# FINAL MITIGATION PLAN

**Matthew Site  
Johnston County, North Carolina**

**DMS Project #: 100043  
Contract #: 7419  
USACE Action ID: SAW-2018-01256  
DWR Project #2017-0624  
RFP: 16-007279**

SUBJECT: Matthew Mitigation Site - NCIRT Comments during 30-day Mitigation Plan Review

**Figure 11 - Monitoring Plan Map**  
**Matthew Mitigation Site**  
 Johnston County, North Carolina

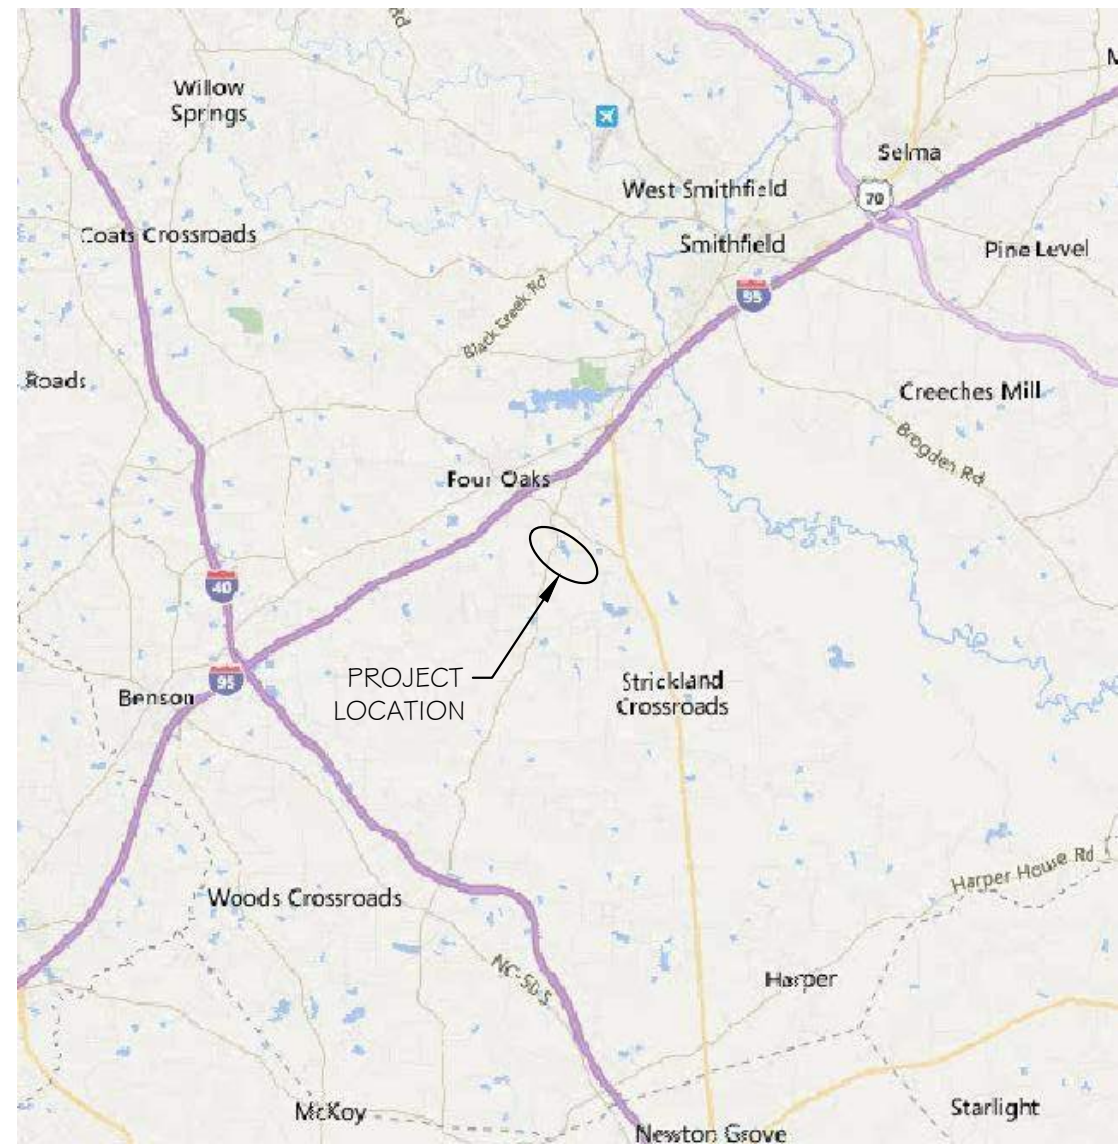
5. Figure 11- Monitoring Plan Map- DWR recommends adding 3 wetland monitoring gauges, two to the rehabilitation area and one to the proposed re-establishment area (will note preferred location during Design Sheet discussion).

2. Please depict fixed photo points/digital image stations on Figures 11.
3. General Comment Wetland rehabilitation/reestablishment—It would be beneficial to add some coarse woody debris to the depressional areas and throughout the wetland for habitat, and to help store sediment, increase water storage/infiltration, and absorb water energy during overbank events.

Wetland monitoring gauges have been added to the preferred locations

13. Please depict fixed photo points/digital image stations on Figure 11.  
**Section 8.2** has been revised to clarify the locations of digital image stations. Specifically, the revised statement reads, "Digital images will be taken at fixed representative locations to record each monitoring event, as well as any noted problem areas or areas of concern. Fixed image locations will exist at each cross section, each vegetation plot, each stage recorder, and each groundwater well." RES believes that these images, along with images of any problem areas, will provide sufficient visual evidence of the Project's progression. Additionally, **Figure 11** has been revised to include a note stating the locations of fixed image locations. It is RES' opinion that adding many more points at each of these locations to the figure will distract in an already complex visual.
-

SHEET NUMBER:  
**S1**

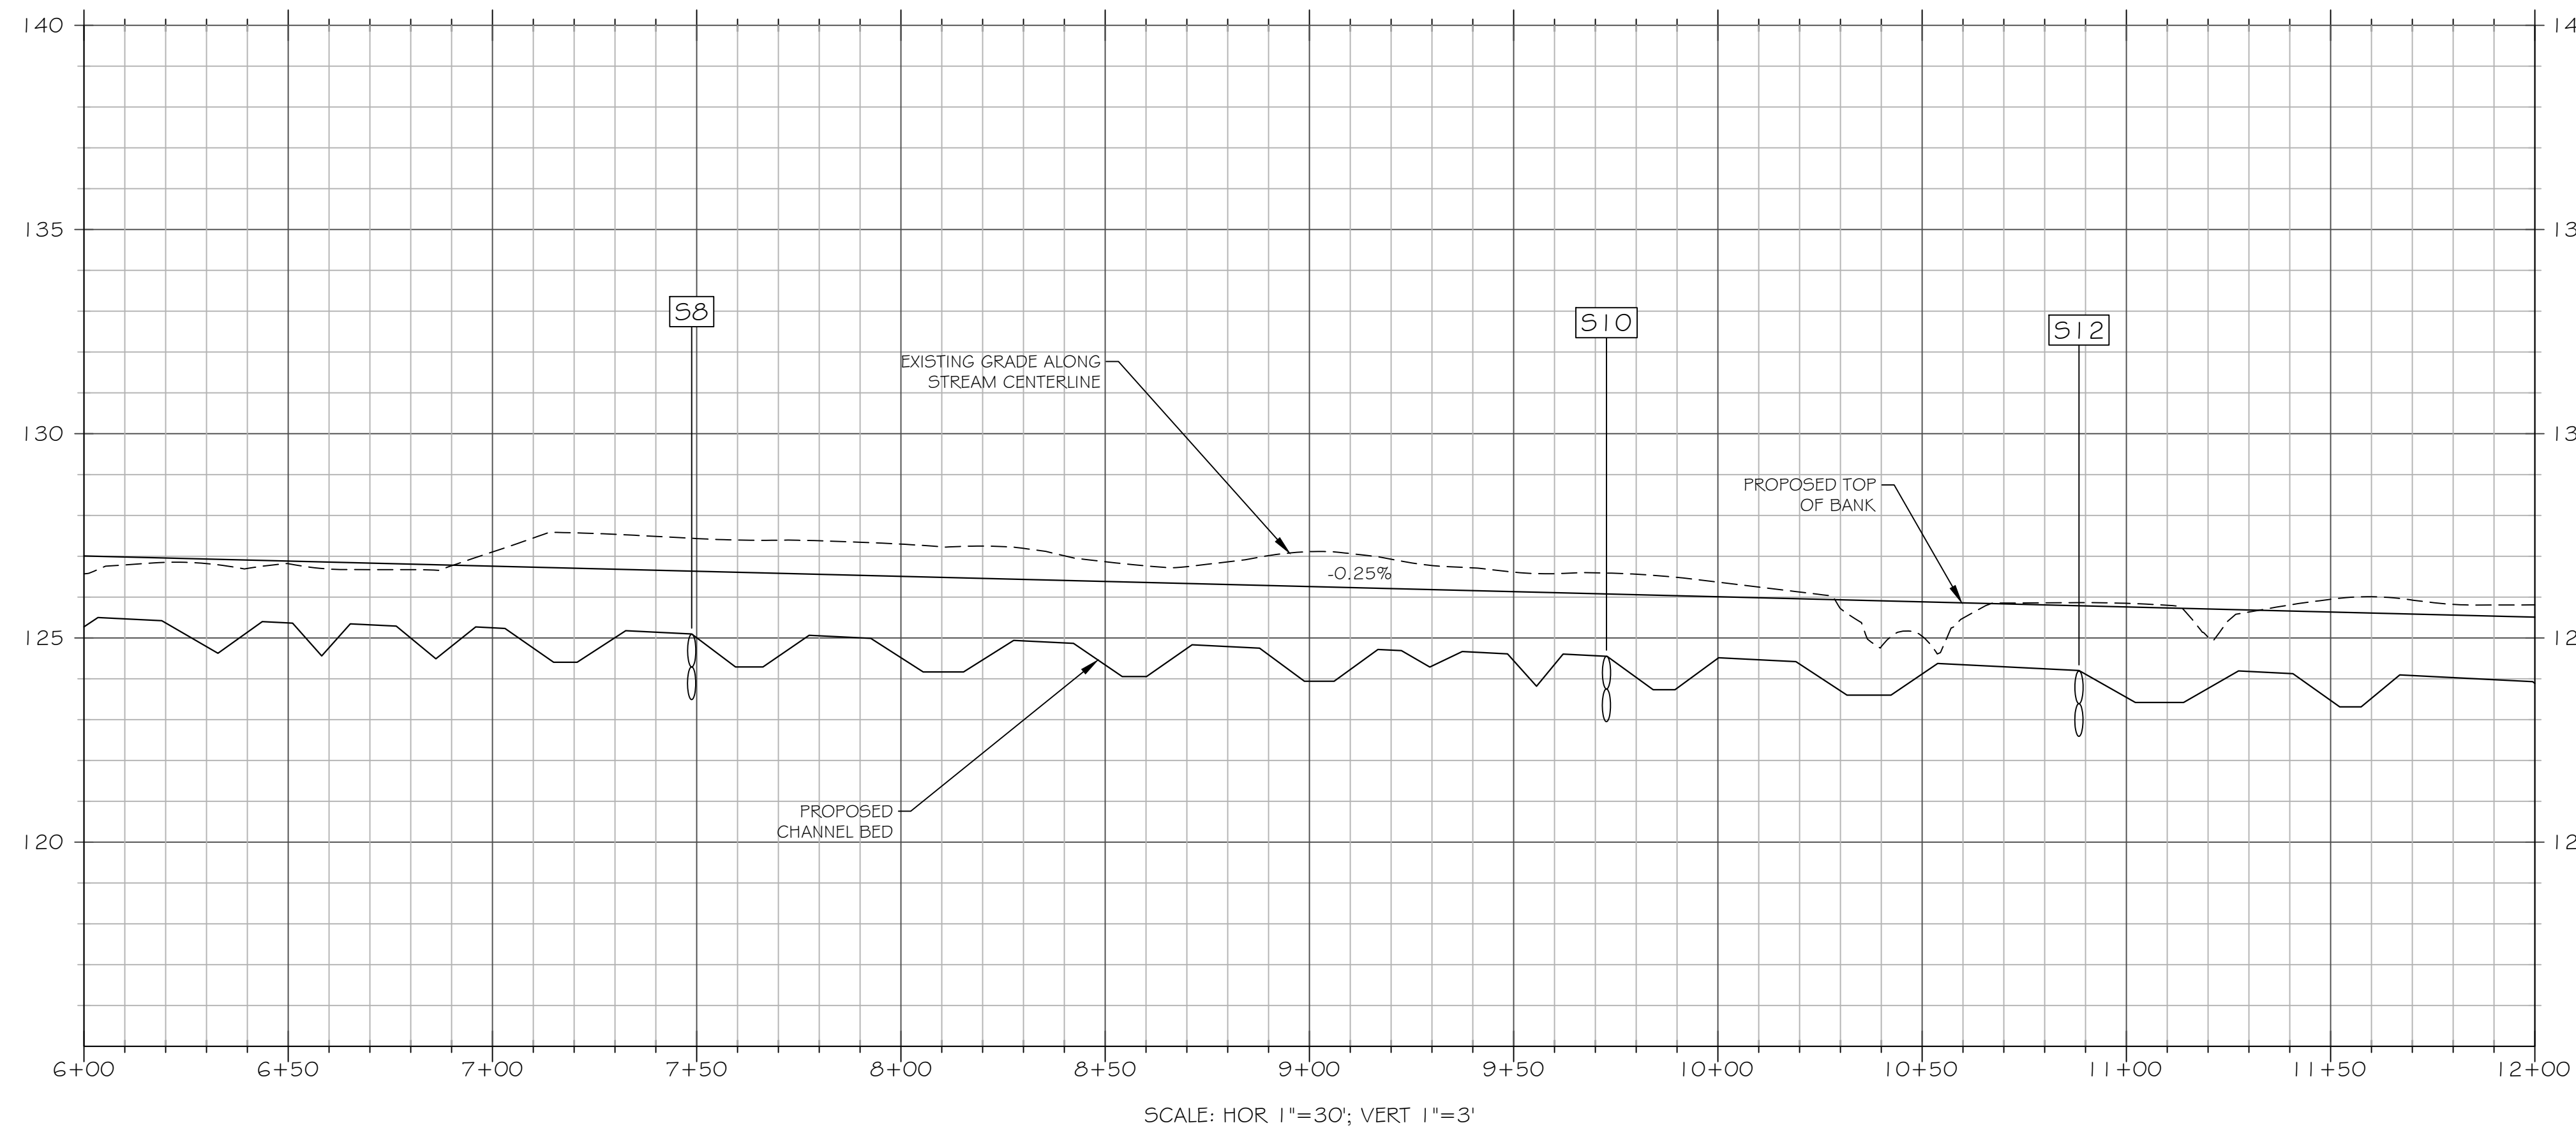
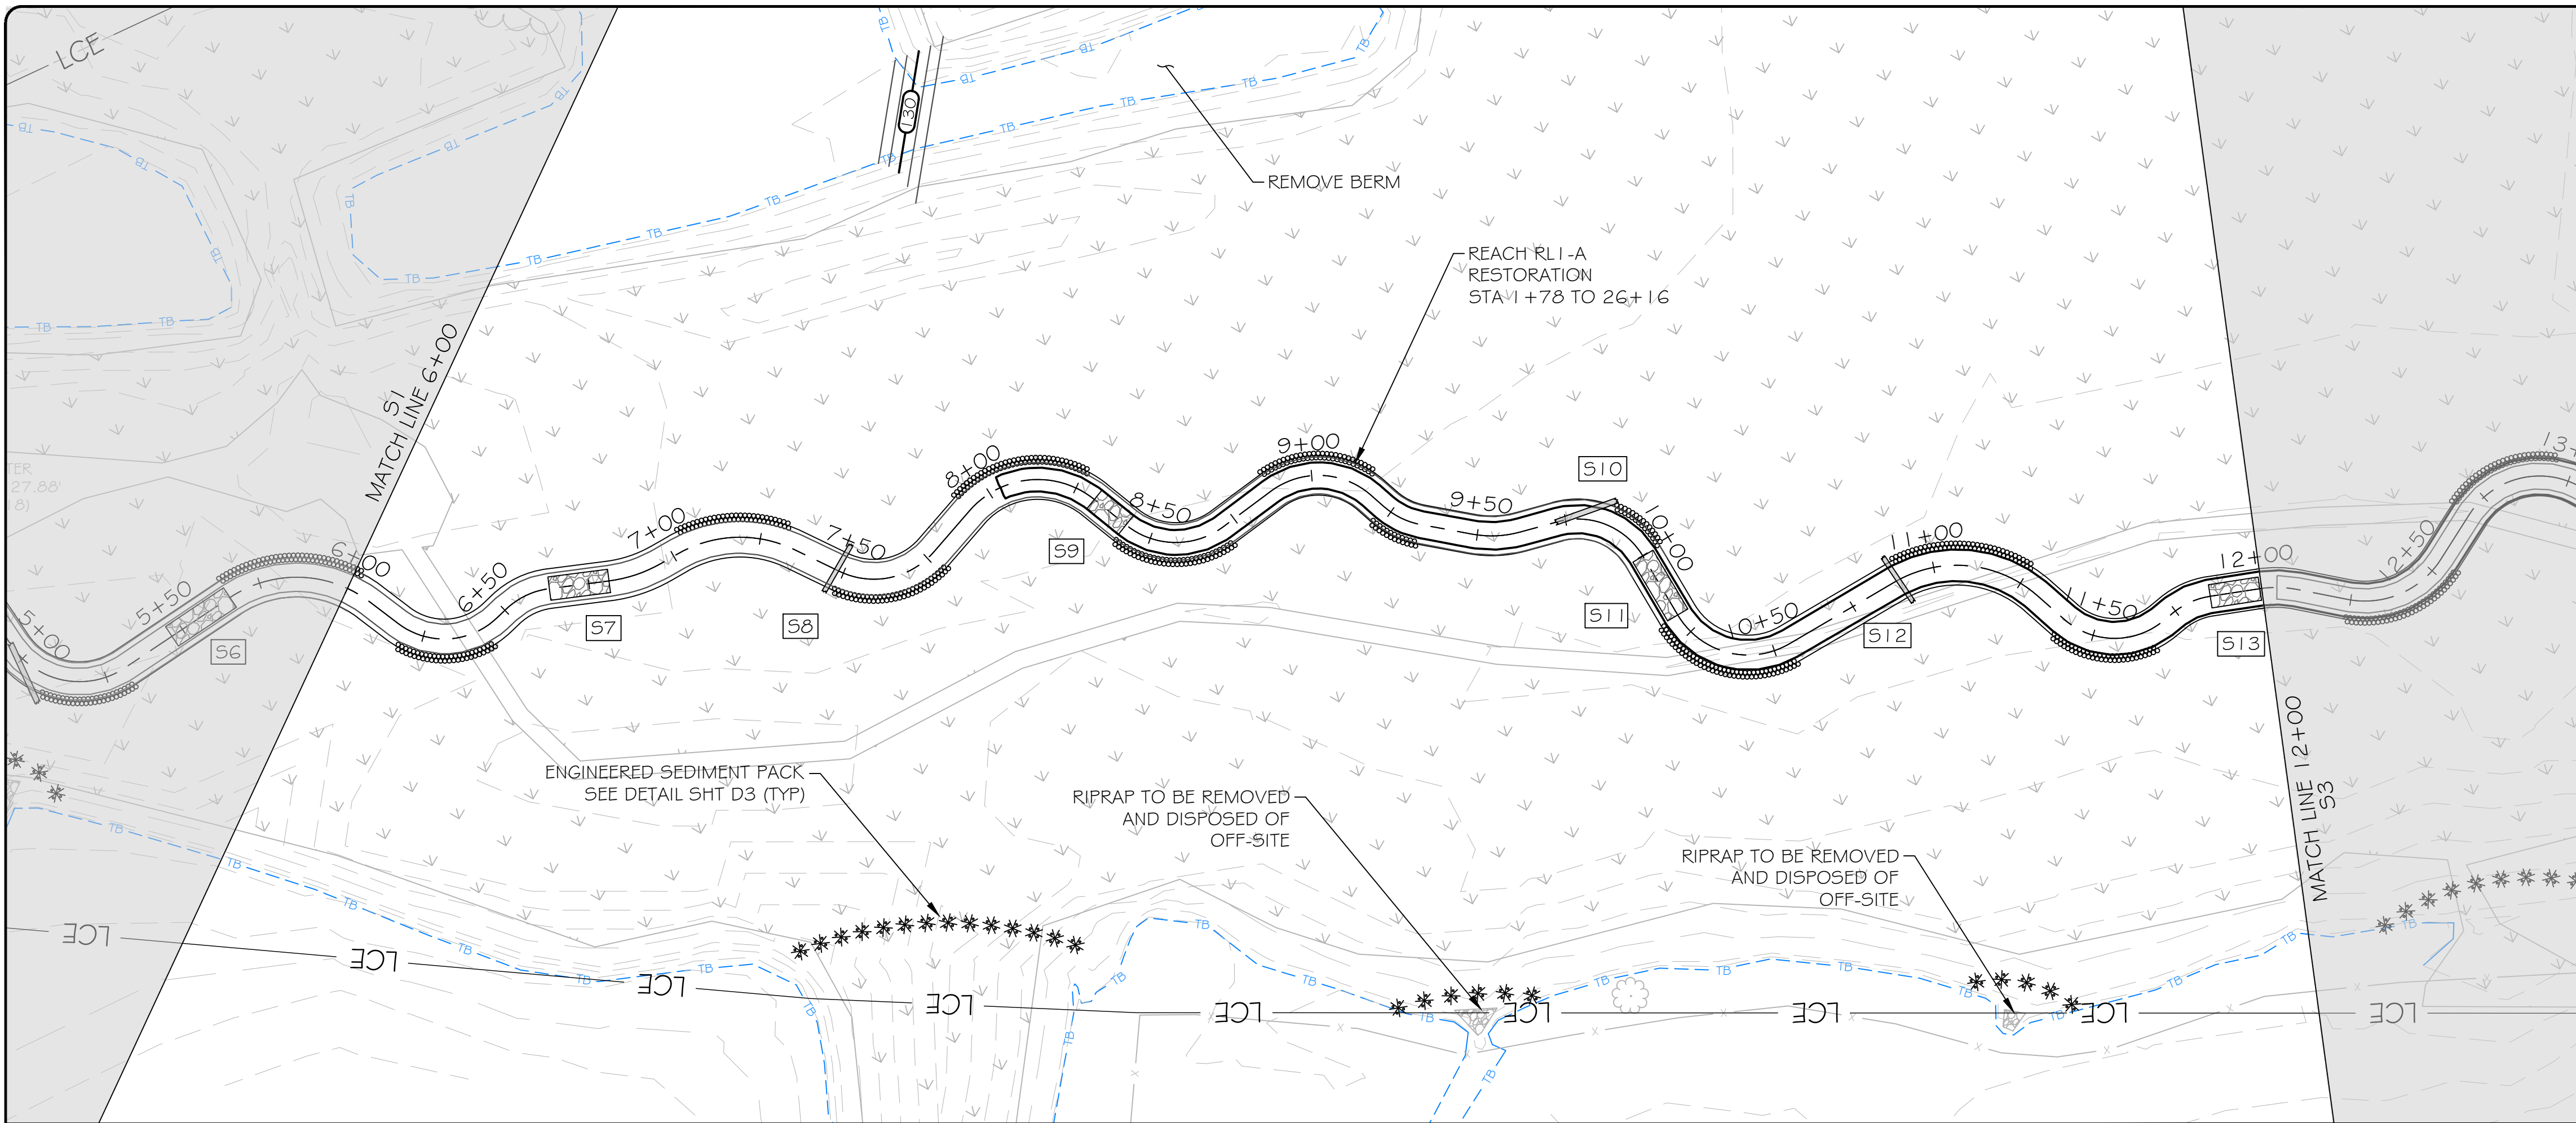
14. Design Sheet 1- What are the structures that will be used for bank stabilization and protection of the structure at the top of the project?
15. The site has been logged since our site visit. There appear to be a couple of drainages coming into the easement area (as seen on Google Earth) on the north side of the easement that may warrant the sediment pack application, DWR recommends looking at these areas and consider the appropriate action.

14. **Design Sheet S7** - Wetlands should be shown on the sheet.  
Wetland areas have been shown on Sheets S6 and S7
15. **Design Sheet 1** - What are the structures that will be used for bank stabilization and protection of the structure at the top of the project?  
A plunge pool and boulder toe are proposed just downstream of the culvert. Additional stabilization measures will include installing turf reinforcement matting along the left upper bank and floodplain bench. See revised Sheet S1.

WOODY RIFFLE  
NTS

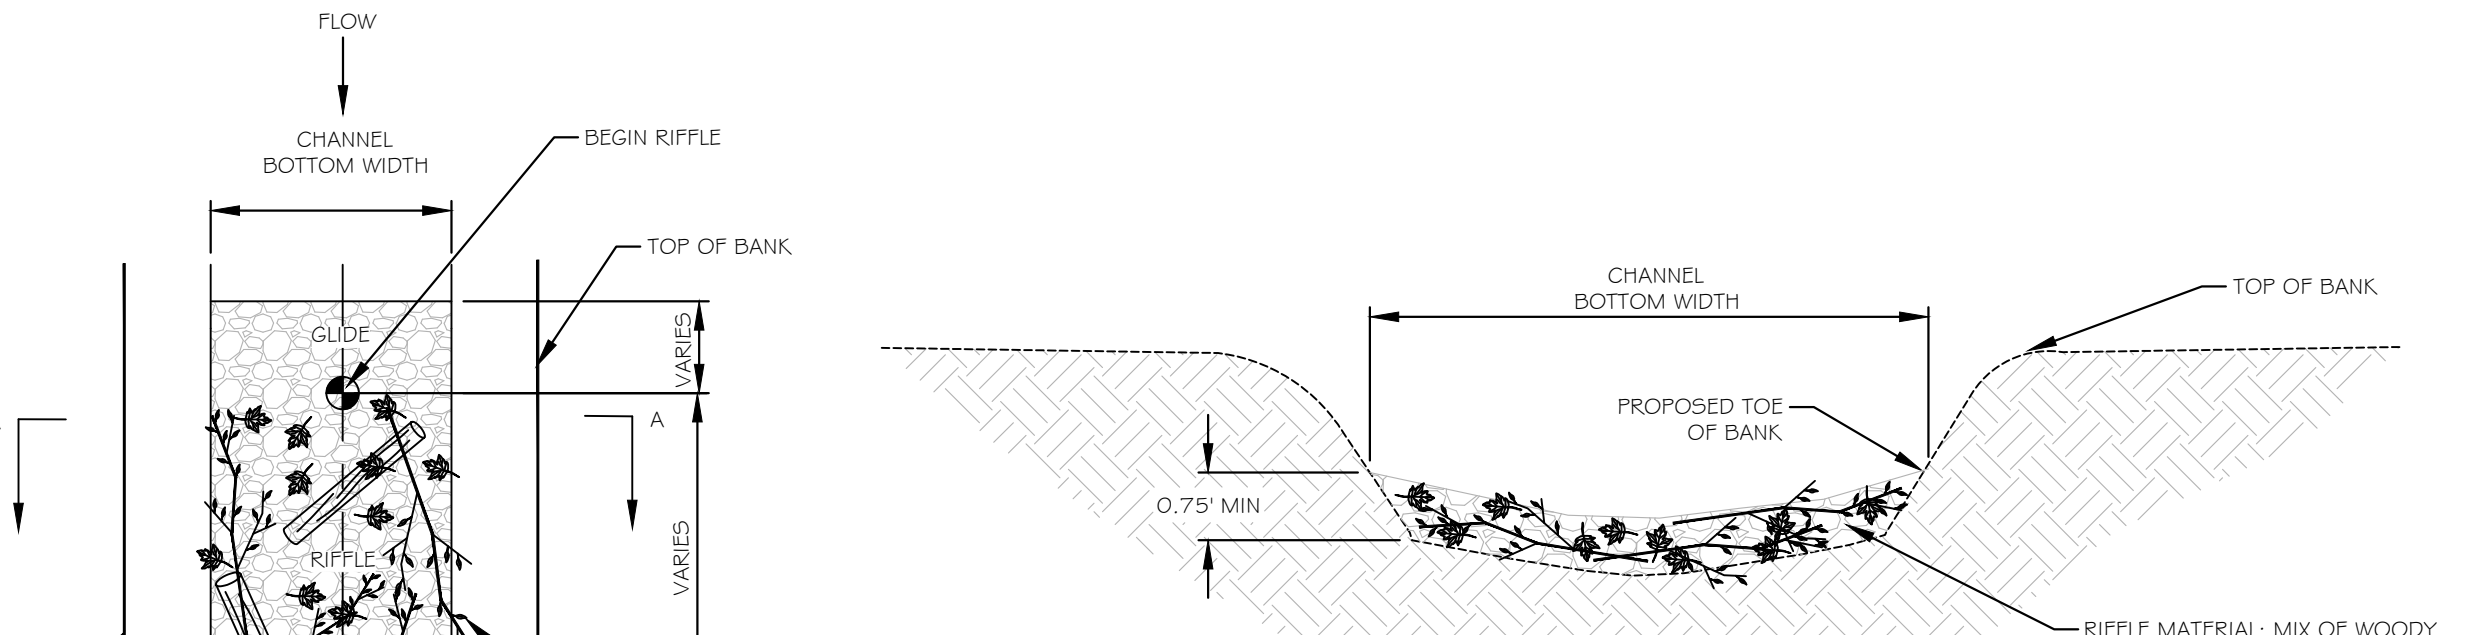
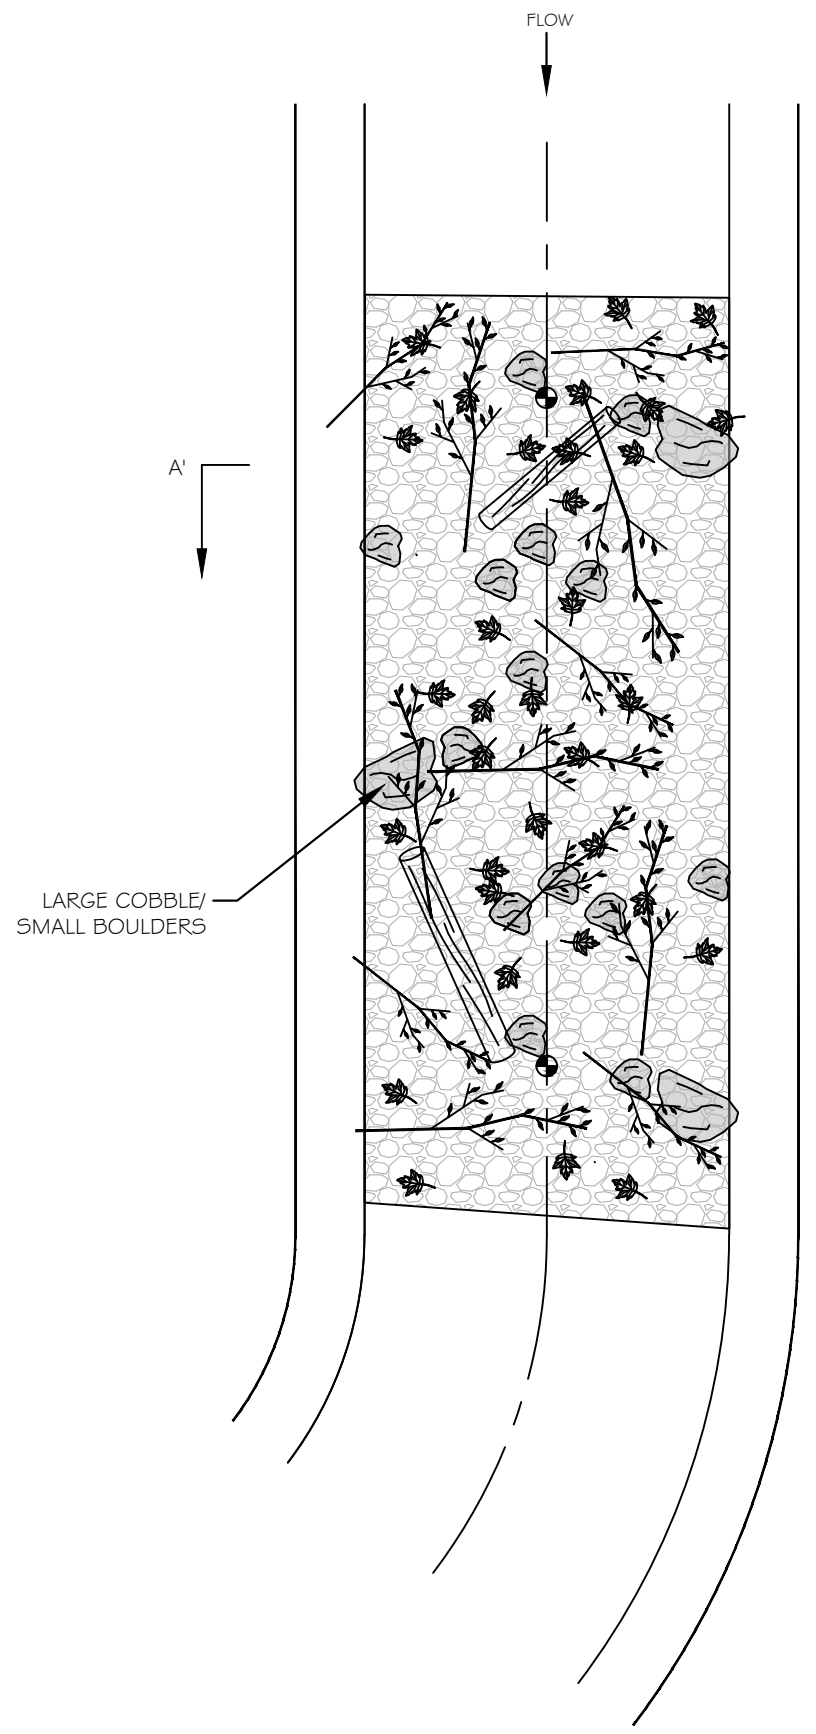
6. Design Sheet E1- RES has a typical for a woody riffle (which is good!), however, it does not appear in the legend, nor does it appear on any of the design sheets. DWR strongly recommends that most of riffles be woody riffles.

10. **Design Sheet E1** - RES has a typical for a woody riffle (which is good!), however, it does not appear in the legend, nor does it appear on any of the design sheets. DWR strongly recommends that most of riffles be woody riffles.

Woody Riffle detail has been renamed Typical Woody Riffle. Callouts have been added to the Notes/Legend sheet to reflect its use in all riffle sections unless otherwise noted
